**Our Case Number:** ABP-314724-22

**Re:** Railway (Metrolink - Estuary to Charlemont via Dublin Airport) Order [2022]  
Metrolink. Estuary through Swords, Dublin Airport, Ballymun, Glasnevin and City Centre to Charlemont, Co. Dublin

**Re: Railway (Metrolink–Estuary to Charlemont via Dublin Airport) Order 2022 –  
Submissions by the Commissioners of Public Works in Ireland**

*This submission is made in response to the statutory review of the Draft Railway Order. Accordingly, this submission has been prepared in the context of “Draft Railway Order 2022; MetroLink - Estuary to Charlemont via Dublin Airport” which seeks to deliver the construction of a fully segregated and automated railway and metro mostly underground c. 18.8km in length with 16 stations running from north of Swords at Estuary through Swords, Dublin Airport, Ballymun, Glasnevin, and the City Centre to Charlemont. The Draft Order is currently on public display. We would respectfully request that An Bord Pleanála consider the content within this submission. DOWNEY would like to thank the Board for the opportunity to make this submission, on behalf of the Commissioners of Public Works in Ireland (hereinafter the Offi

Figure 9. Plan Showing Horizontal Alignment (extract from ML1-JAI-EIA-ROUT\_XX-DR-Y-05025)

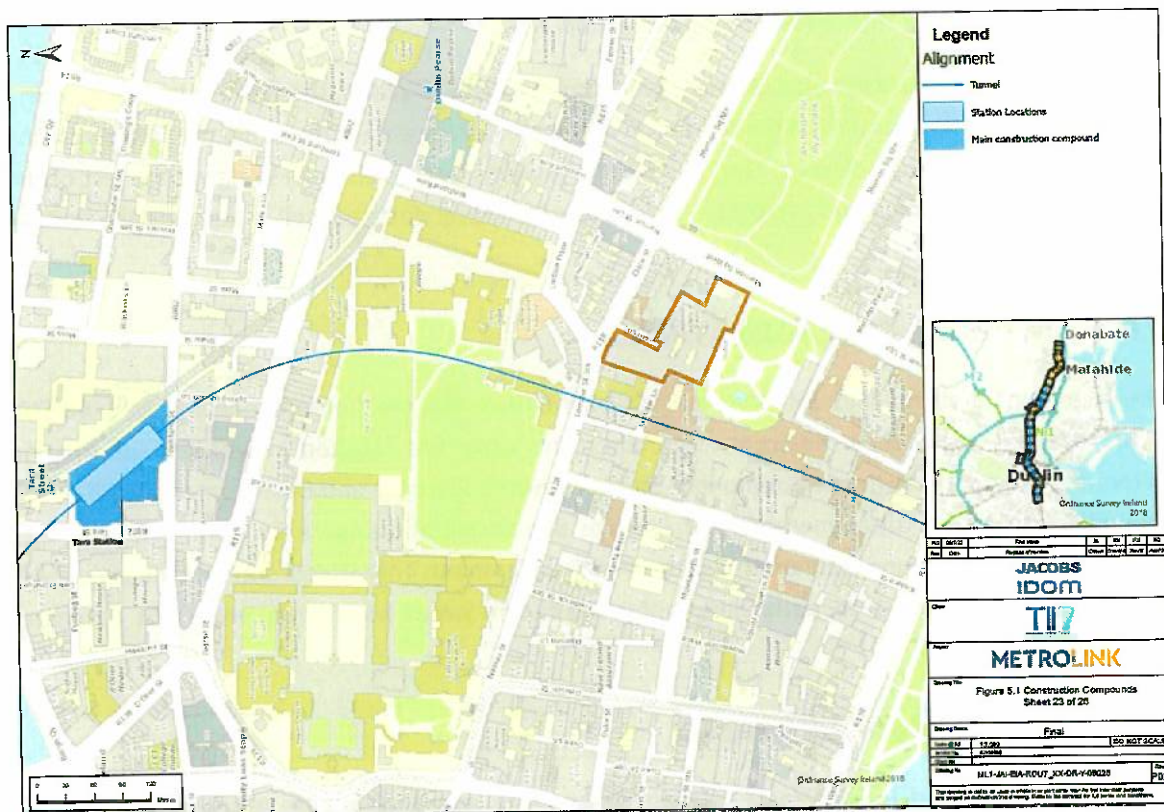
The alignment drawing ML1-JAI-EIA-ROUT\_XX-DR-Y-04025 and the Contour drawing ML1-JAI-EIA-ROUT\_XX-DR-Y-21148 show different alignments. This error has resulted in deficient information within the SID application submitted under Section 2 of the Planning and Development Act 2000 (as amended), to assess the vulnerability of damage due to vibration cause by both tunnelling and operation of underground train on this section of the alignment. This affects several buildings under the management of the OPW, particularly within the Kildare Street, Merrion Square and St. Stephen's Green areas.

The tunnel alignment does not pass directly beneath the NGL, however there is inconsistency in the alignment between Tara Station and St. Stephen's Green. The alignment drawing ML1-JAI-EIA-ROUT\_XX-DR-Y-05025 and the Contour drawing ML1-JAI-EIA-ROUT\_XX-DR-Y-21148 show different alignments.

Figure 11. Settlement Contours (Extract from ML1-JAI-EIA-ROUT\_XX-DR-Y-21148)

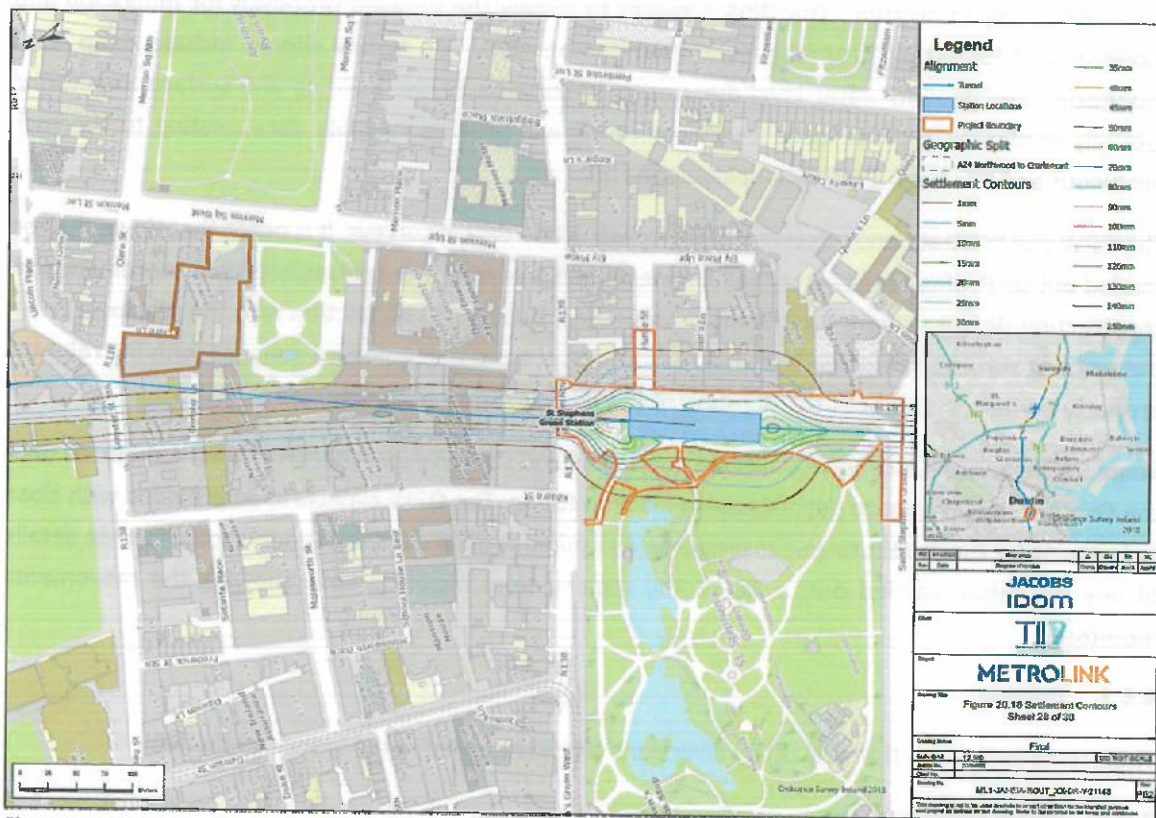
**Stage 1:** Defines extent of ground movement using Moderately Conservative parameters. The parameters considered by MetroLink are:

**Stage 3:** The EIAR states that a Stage 3 assessment will be carried out for the NGI by the Contractor appointed to construct this section of the MetroLink. The OPW expects to be consulted on the detail, scope of this assessment and programme for these assessments. It would be helpful if TII were to develop a Design Standard to ensure that all Stage 3 analyses of the OPW properties are carried out equally.
